Addendum 13 – Regulation No. 14

Revision 5 - Amendment 1

Supplement 4 to the 07 series of amendments – Date of entry into force: 15 July 2013

Uniform provisions concerning the approval of vehicles with regard to safety-belt anchorages, ISOFIX anchorages systems and ISOFIX top tether anchorages and i-Size seating positions

Figure 1
3D view of the support leg foot assessment volume

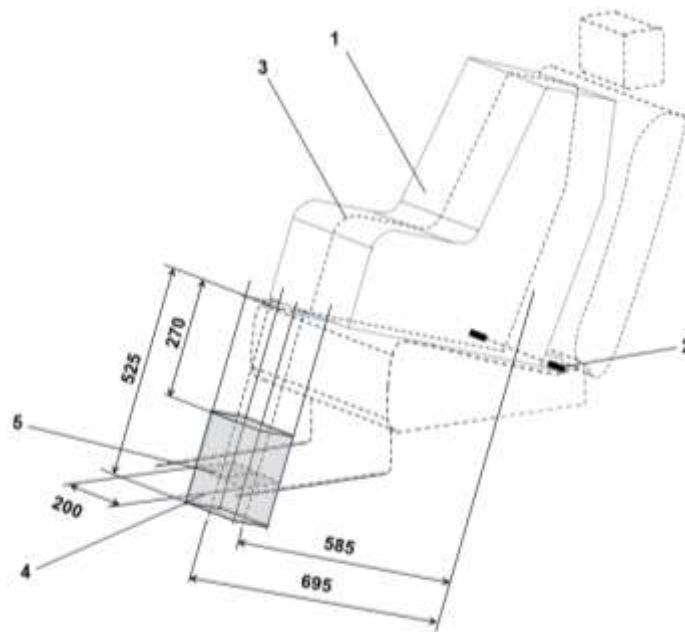
"2.30. *"Support leg foot assessment volume"* means the volume, as shown in Figures 1 and 2 of Annex 10 of this Regulation, in which the support leg foot of an i-Size child restraint system defined in Regulation No. 129 will rest and therefore the vehicle floor has to intersect.

In addition to the requirements defined in 5.2.3. and 5.2.4. it shall be verified that the upper surface of the vehicle floor (incl. trim, carpet, foam, etc.) intersects with both of the limiting surfaces in the x- and y-directions of the support leg foot assessment volume, as shown in figures 1 and 2 of Annex 10 to this Regulation.

The support leg foot assessment volume is characterized as follows (see also Annex 10, Figures 1 and 2 of this Regulation):

- (a) In width, by the two planes parallel to and 100 mm apart from the median longitudinal plane of the child restraint fixture installed in the respective seating position; and
- (b) In length, by the two planes perpendicular to the plane given by the child restraint fixture bottom surface and perpendicular to the median longitudinal plane of the child restraint fixture, 585 mm and 695 mm apart from the plane passing through the centerlines of the ISOFIX lower anchorages and being perpendicular to the CRF bottom surface; and
- (c) In height, by two planes which are parallel to and 270 mm and 525 mm below the child restraint bottom surface.

Insert a new Annex 10, to read:

Figure 3
Example for a modified Static force application device with support leg test probe (SFAD_{SL}) showing the required adjustment range and dimensions of the support leg foot

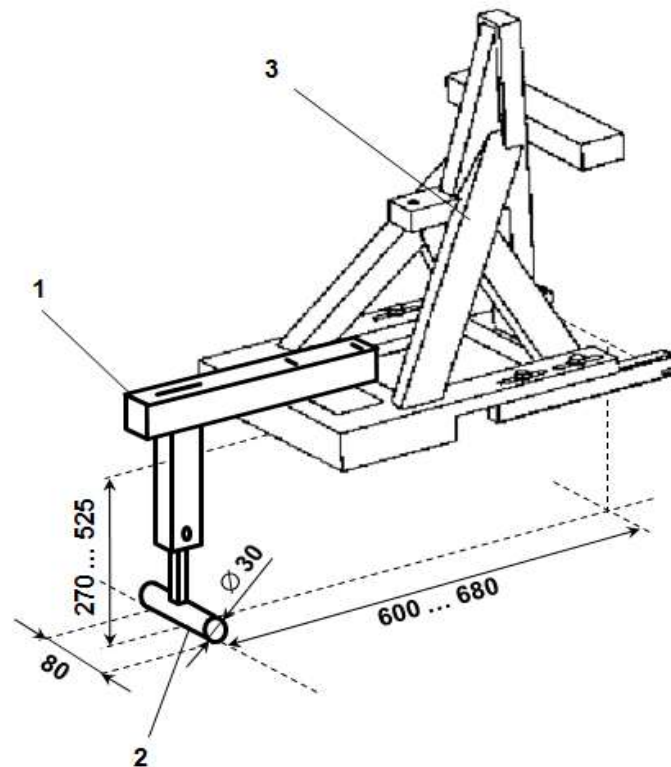
In addition to the tests specified in paragraphs 6.6.4.3. and 6.6.4.4., a test with a modified static force application device, which consists of a SFAD and includes a support leg test probe as defined in Figure 3 of Annex 10, shall be performed. The support leg test device shall be adjusted in length and width to assess the vehicle floor contact surface, as defined in paragraph 5.2.5.2. (see also Figures 1 and 2 of Annex 10 to this Regulation). The height of the support leg test device shall be adjusted in a way that the foot of the support leg test device is in contact with the upper surface of the vehicle floor. In case of incremental height adjustment, the first notch where the foot rests stable on the floor shall be chosen; in case of a non-incremental/continuous adjustment of the support leg test device height, the pitch angle of the SFAD shall be increased by 1.5 +/- 0.5 degrees due to the height adjustment of the support leg test device.

The horizontal excursion (after pre-load) of point X of the SFAD during application of the 8 kN ± 0.25 kN force shall be limited to 125 mm and permanent deformation including partial rupture or breakage of any ISOFIX low anchorage and the vehicle floor contact surface, or surrounding area shall not constitute failure if the required force is sustained for the specified time."

Figure 4
Symbol used to identify an i-Size seating position

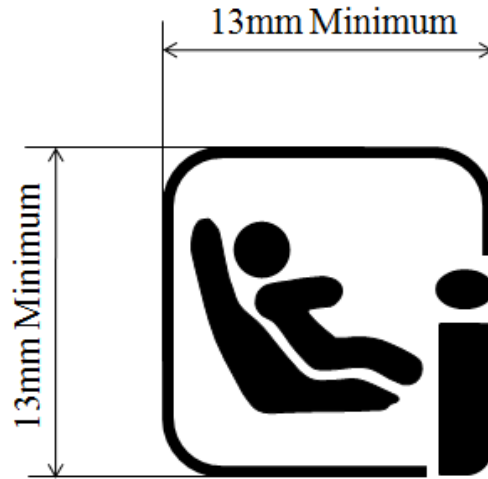
The minimum marking shall be the symbol of Annex 10, Figure 4 consisting of a square with a minimum size of 13 mm and containing a pictogram and meeting the following conditions:

(a) The pictogram shall contrast with the background of the square;

(b) The pictogram shall be located close to each bar of the system.
